EUROMOT POSITION

23 January 2015

Comments on Maltese Plant Data Submitted by EEB (European Environmental Bureau) on 3 December 2014

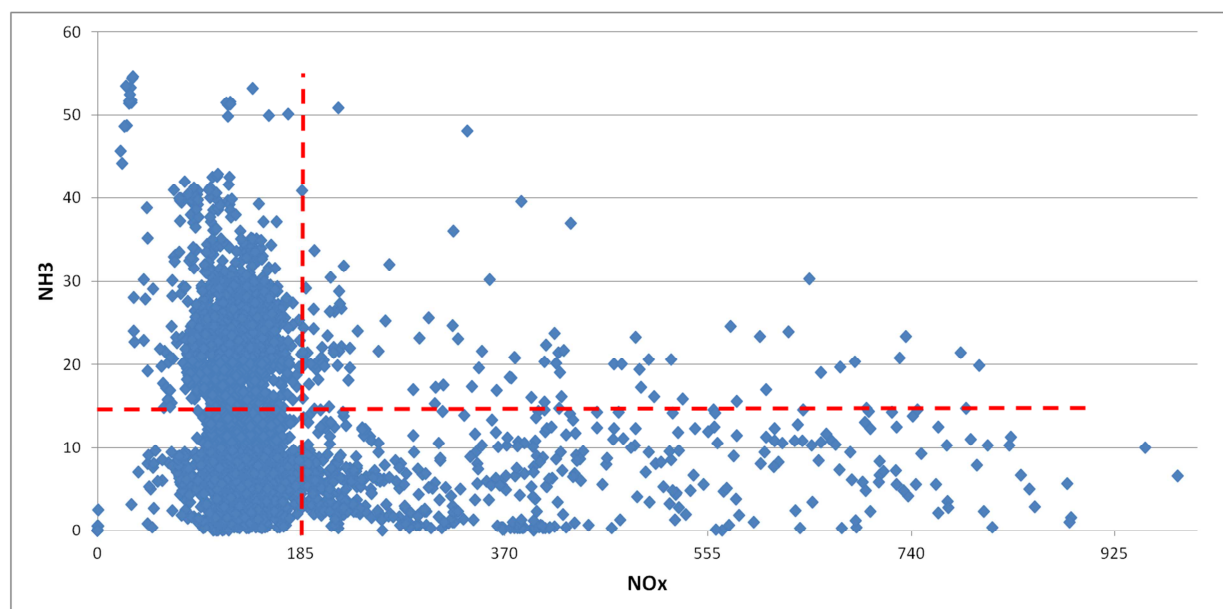
In Annex 1 is stated regarding the SCR:

- c) “With regards to NO_x emissions, there was a particular problem during the first year of operation - instability of NO_x abatement due to the following faults: (a) UREA injection; (b) feedback control system”.

Based on above “fault” %-figures (7.1 ... 32.2 %) big availability issues with the SCR seem to exist in the Delimara plant, the current performance is not at a satisfactory level yet (still after one year of operation) and still the final tunings/adjustments, etc. are to be conducted.

Graph 2: Stack “6B” measured NH₃ and NO_x one-hour averaged values year 2013, emission unit mg/Nm³ (15 % O₂). With “filter lines” (see Annex 1 for more information): for NH₃ 15 mg/Nm³ and NO_x 185 mg/Nm³. Concentration reference point 15 % O₂.

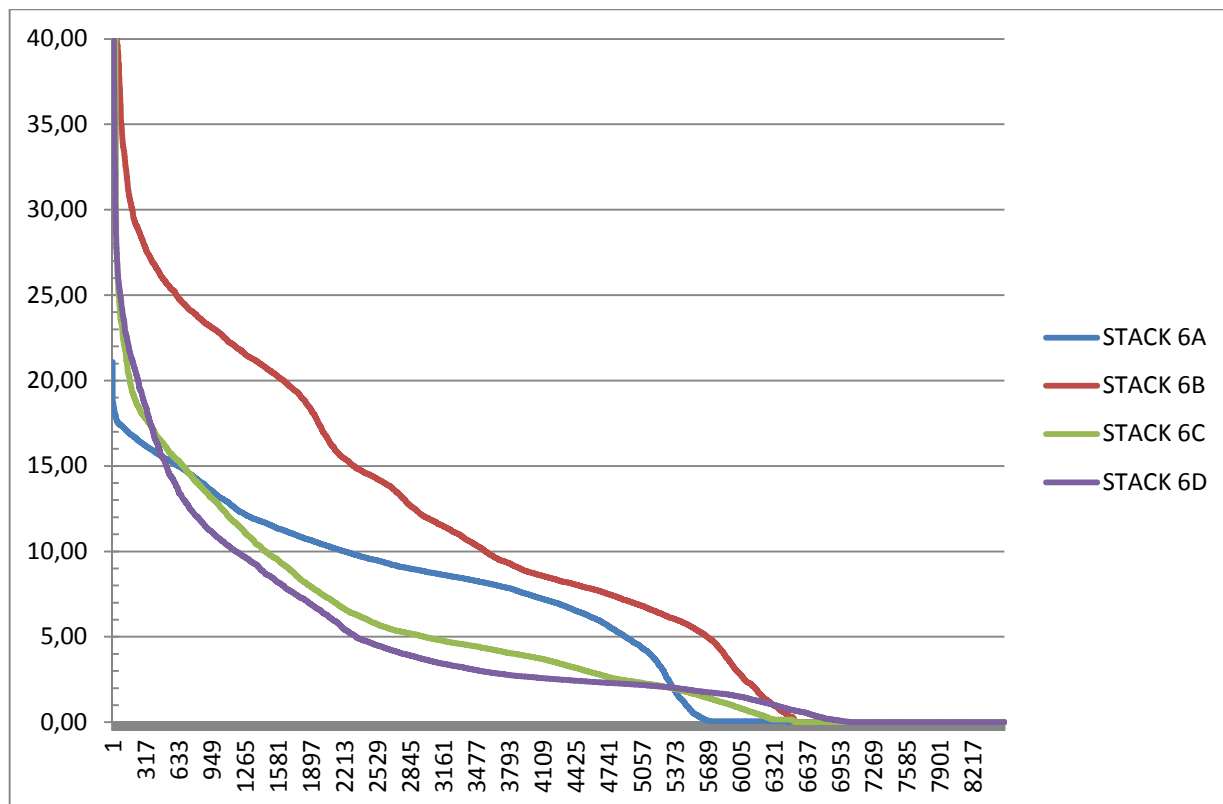
In below graph 2 the measured (raw data), NO_x and NH₃ figures from “Stack 6B” are shown:

ANNEX 3: Year 2013 - Raw measurement data (1 hour averaged values year 2013, emission unit mg/Nm³ (15 % O₂) graphs with “filter lines” inserted - NO_x and NH₃ for stacks “6A”, “6B”, “6C” and “6D”.

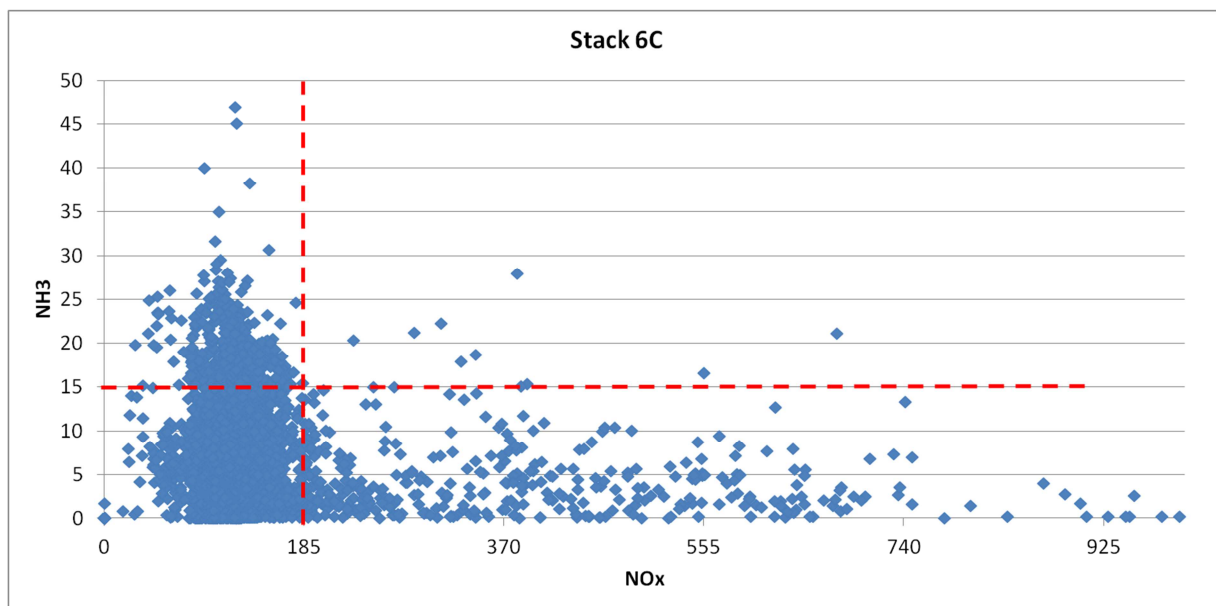
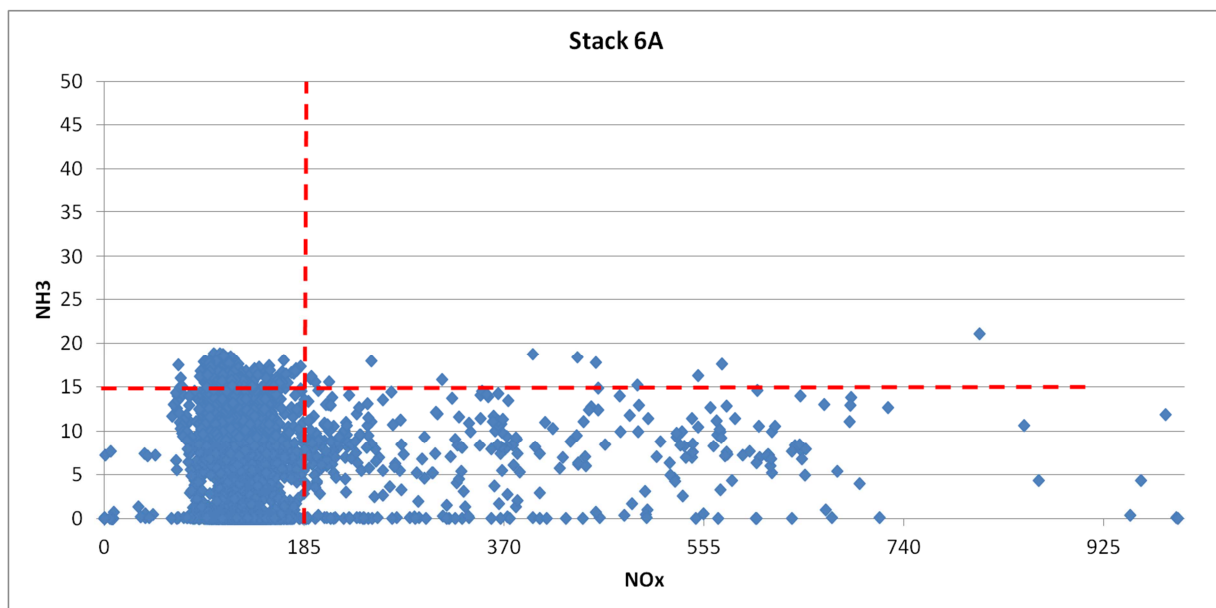
In Annex 3 the NO_x/NH_3 -graphs for stacks “6A”, “6B”, “6C” and “6D” are shown based on the raw data measurement results (available in BATIS) for year 2013 from the Enemalta (Delimara) plant. Some of the “exceeding” NO_x -values are likely due to starts and stops of the engines; others are due to “instabilities”, etc. of the SCR systems (see also page 2 of Annex 1).
